Sun StorEdge network FC switch-8 and switch-16 Release Notes

Part No. 806-6924-14
February 2001, [Revision A](#)

FIGURE 1 Example: Single Host Connected to Multiple StorEdge T3 Partner Pairs, Using Switches

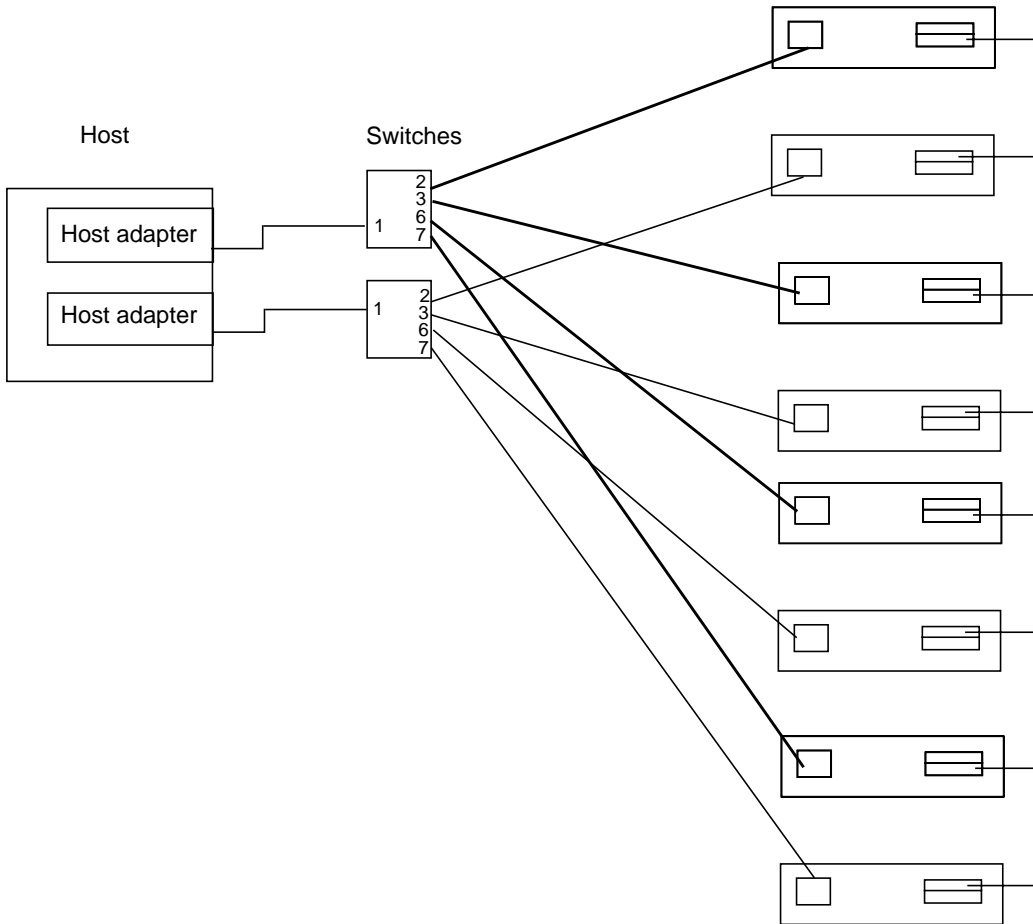
The *Sun StorEdge network FC switch-8 and switch-16 Installation and Configuration Guide* contains incomplete information about the T-3 configuration with the switch.

When used with a switch, the T3 supports a maximum of two initiators per zone for a single T3 brick (one per LUN), and a maximum of one initiator for a T3 partner pair.

Figure 2-6 shows a single host connected to multiple StorEdge T3 partner pairs. The correct port assignments for this configuration follow. See FIGURE 1.

FIGURE 2 Example: Two Hosts Connected to Four StorEdge T3 Partner Pairs, Using Switches

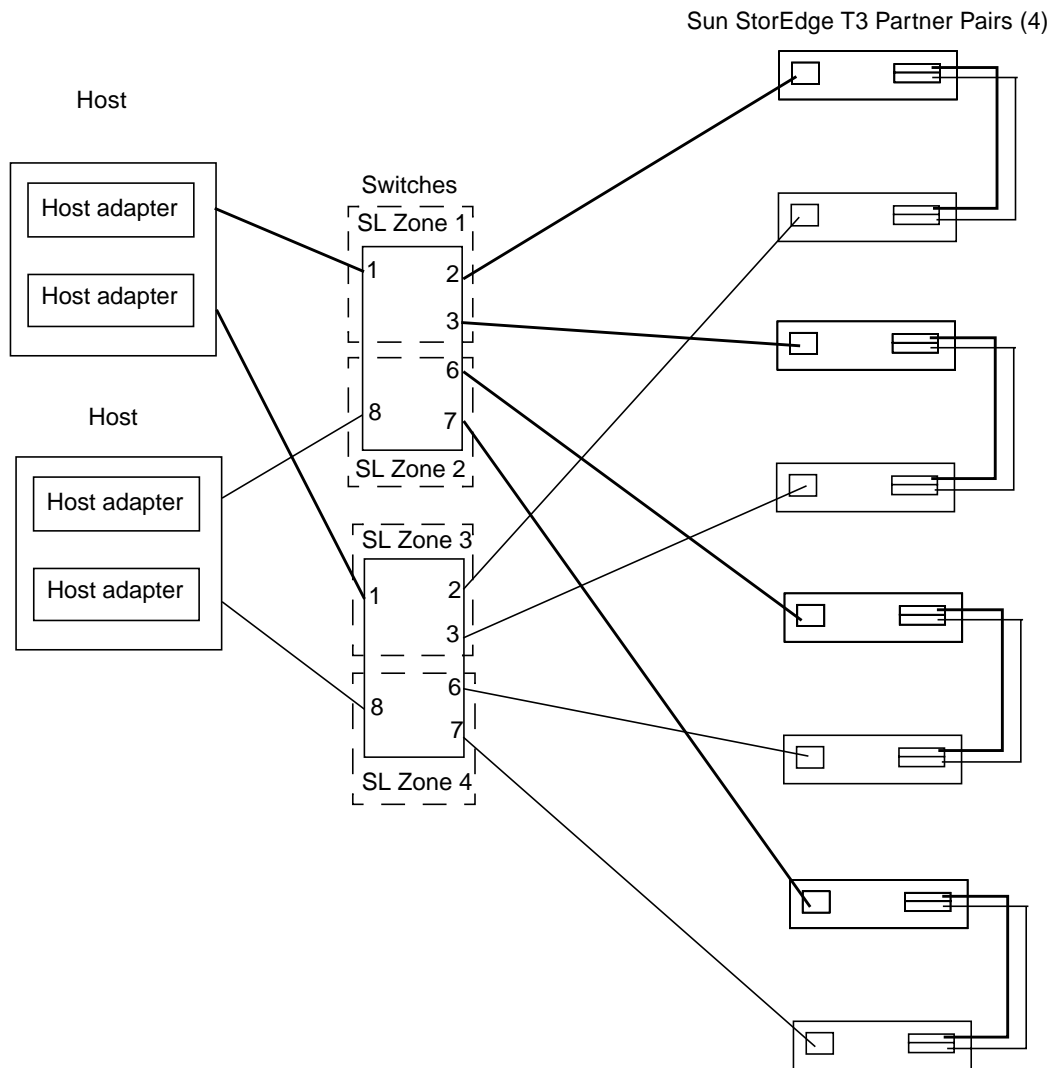
Figure 2-9 of the Installation and Configuration Guide shows a configuration of two hosts connected to four StorEdge T3 partner pairs. Figure 2-9 is incorrect. When multiple hosts are connected to T3s, zoning is needed to ensure that the maximum number of initiators for a T3 partner pair is one per zone. For non partner-pair T3 configurations, one initiator per LUN is allowed, which results in a maximum of two initiators per zone. See FIGURE 2 for the configuration restrictions.
